8911 and 8915 Burdette Road, Administrative Subdivision Plan No. 620170070

Completed: 6/15/18

Description

Figure 4-Administrative Subdivision Plan

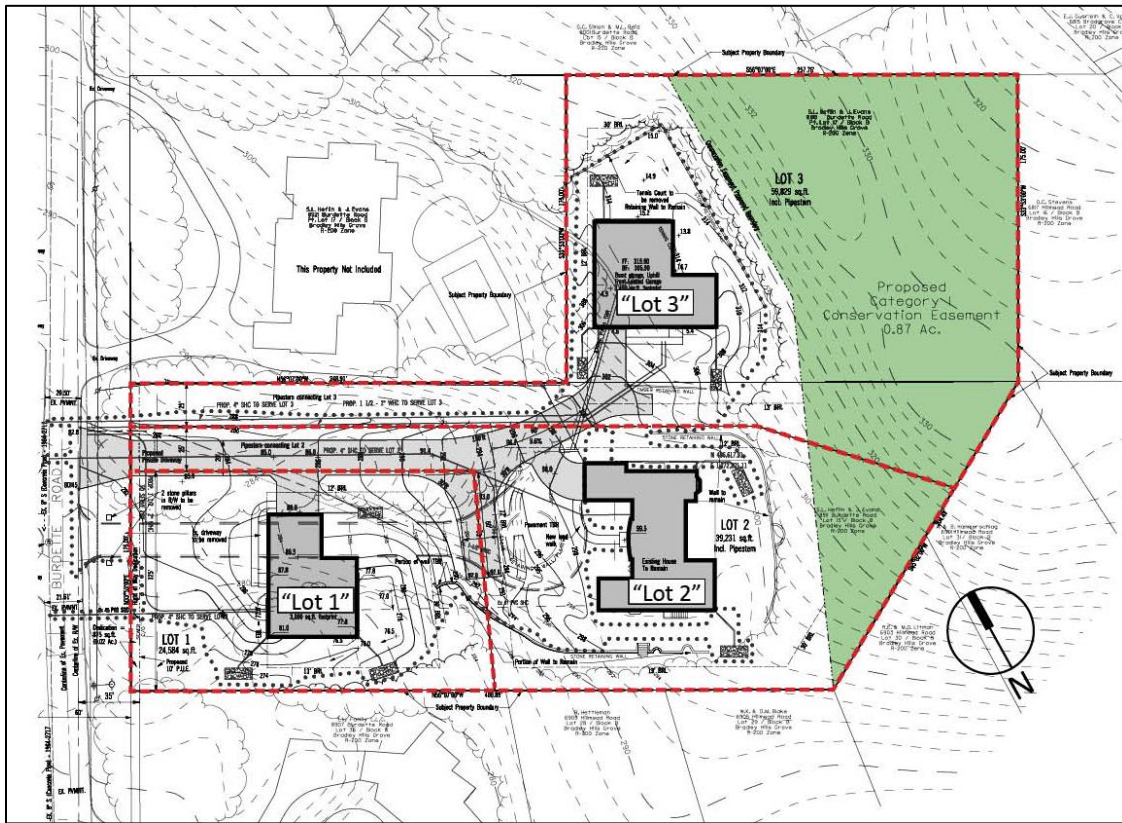
- b. Control of invasive species;
 - c. Cleanup of trash/debris;
 - d. Mitigation tree planting details, and timing for installation;
 - e. Update the FCP sheets to entirely remove the previously proposed overhead electric notes/graphics (within the CRZ of tree 34) and show the proposed utility location similar to the layout on the Certified Administrative Subdivision Plan;

11. The Certified Administrative Subdivision Plan must contain the following note:

“Unless specifically noted on this plan drawing or in the conditions of approval, the building footprints, building heights, on-site parking, site circulation, and sidewalks shown on the Administrative Subdivision Plan are illustrative. The final locations of buildings, structures and hardscape will be determined at the time of issuance of building permit(s) approval. Please refer to the zoning data table for development standards such as setbacks, building restriction lines, building height, and lot coverage for each lot. Other limitations for site development may also be included in the conditions of approval.”

Figure 5- Preliminary Forest Conservation Plan Exhibit

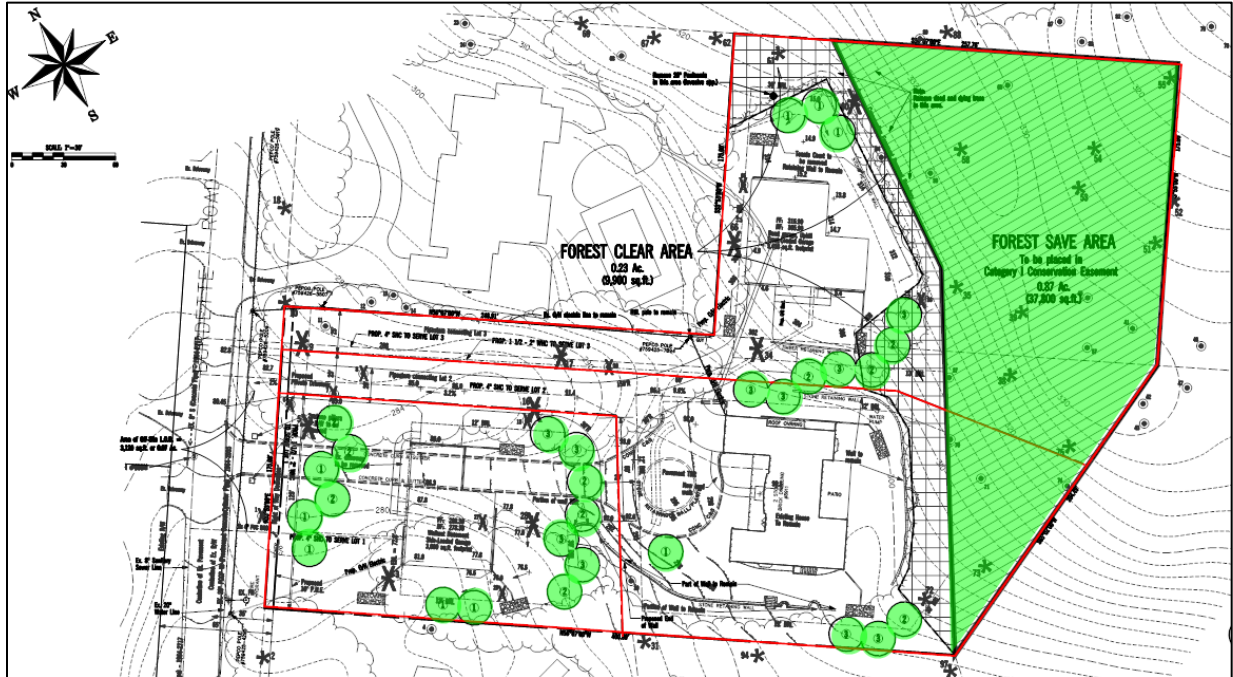
The proposed layout of the subdivision includes a 0.87-acre Category I Conservation Easement at the eastern side of the site which protects most of the onsite forest area. Forest clearing of 0.23 acres is proposed (cross-hatched area in Figure 5 below), however only about 0.02 acres is actively cleared within the limits of disturbance (LOD).

The project includes removals of and impacts to trees measuring 30 inches DBH or greater and are therefore subject to a variance. The Applicant submitted a variance request to remove nine specimen trees and to impact, but retain, eight specimen trees.

The LOD and associated variance request includes the removal of trees 3, 5, 9, 16, 17, 28, 34, 60 & 66, each of which measure 30" DBH or greater, and their total DBH is 338". Planting mitigation for the proposed removals should be at a rate that approximates the form and function of the trees removed, at a ratio of approximately 1" DBH for every 4" DBH removed, using trees that are a minimum of 3" caliper. This means that for the 338 diameter inches of tree to be removed, the Applicant must provide mitigation of at least 84.5 inches of caliper replacements. Therefore, the mitigation requirements are addressed by the planting of 29 (quantity) 3" caliper trees for a total of 87 caliper inches of onsite mitigation trees.

3. The Final Forest Conservation Plan must address the following items:
 - a. Signage, and a split-rail fence and/or boundary posts, to delineate easement areas;

- f. Detailed tree save plan;
 - g. Removal of hazardous trees/limbs; and
 - h. All tree protection measures shown on the plans must be certified by an International Society of Arboriculture certified arborist who is also a Maryland Licensed Tree Care Expert.
